Unit 4 Walls, Trim & Outlets

Room-by-room wall treatment, trim moulding and outlet plan. One section per room with site photos, wall mock-ups and a usability check of every outlet.

WORKING PLAN — not a cut, purchase or electrical release. Written dimensions govern; do not scale drawings. All heights in inches above finished floor (AFF).

East wall · refrigerator run Issued for bid Rev A E-8

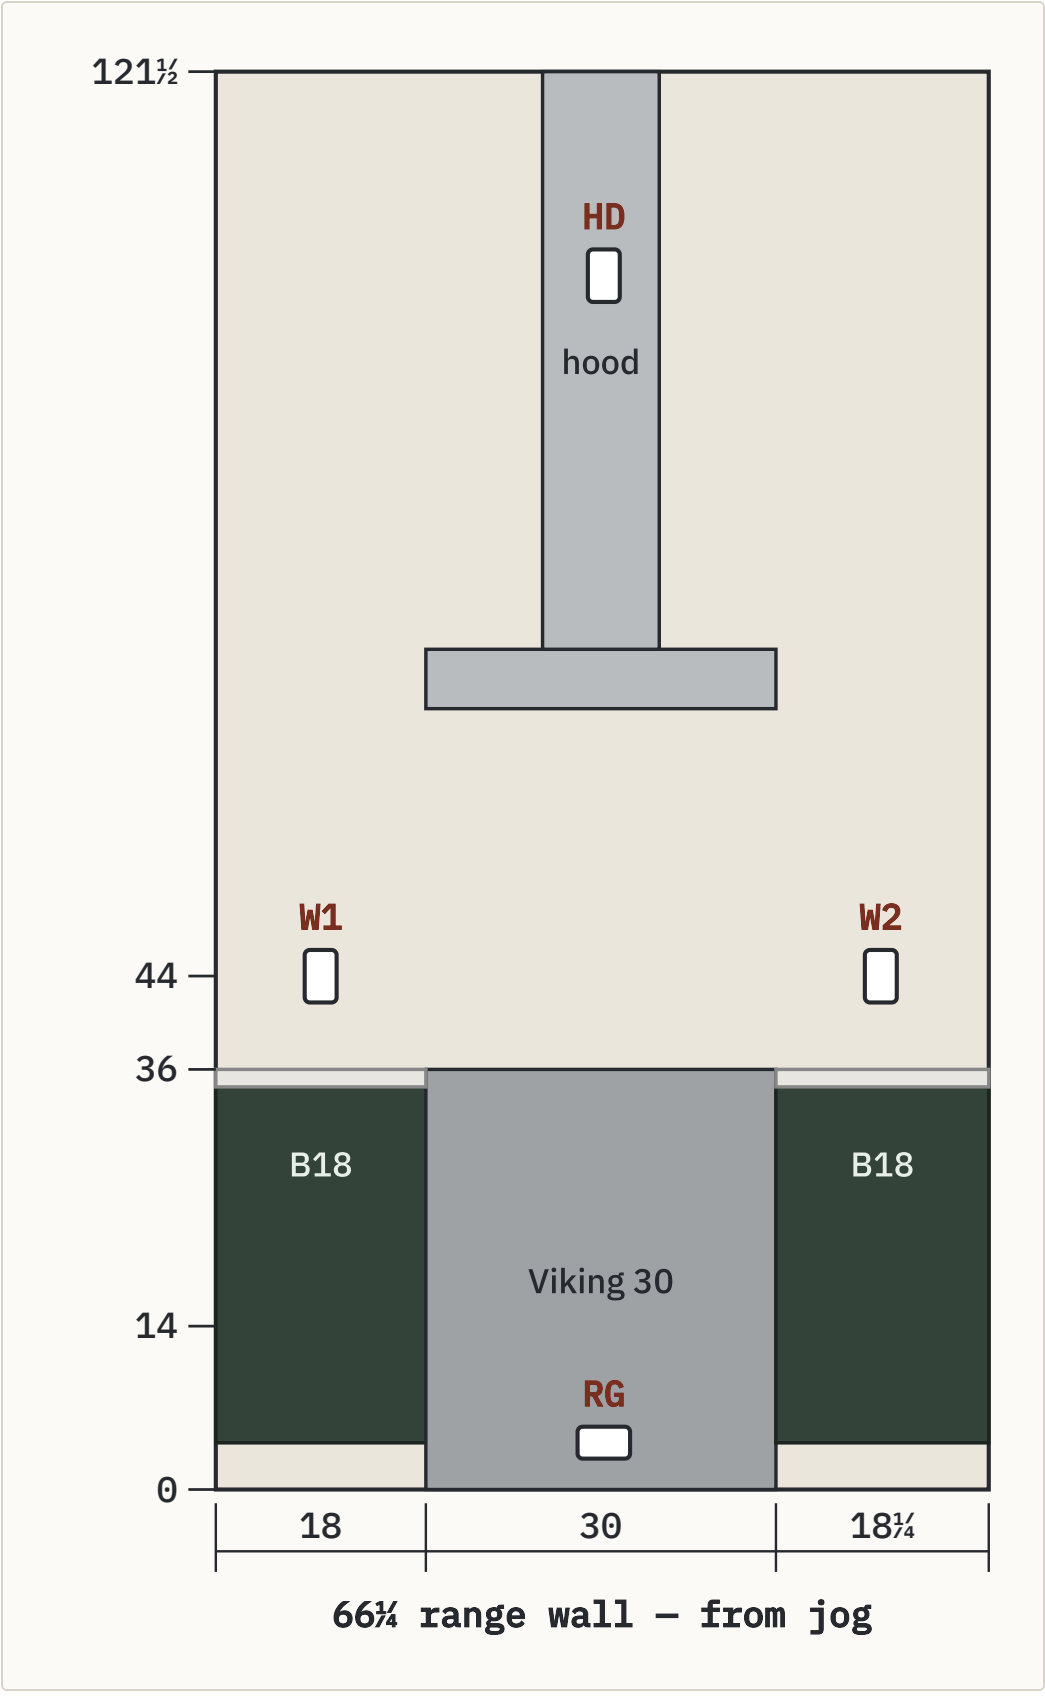
- **E1 is deep in the blind corner.** At 6 in from the SE corner it sits behind a 36-in corner cabinet, about 25 in back and hard to reach. Moving it to about 24 in north (dashed “E1 alt?”) still covers the corner

and keeps E1–E2 spacing at 24 in. Only if Tisa agrees. New suggestion
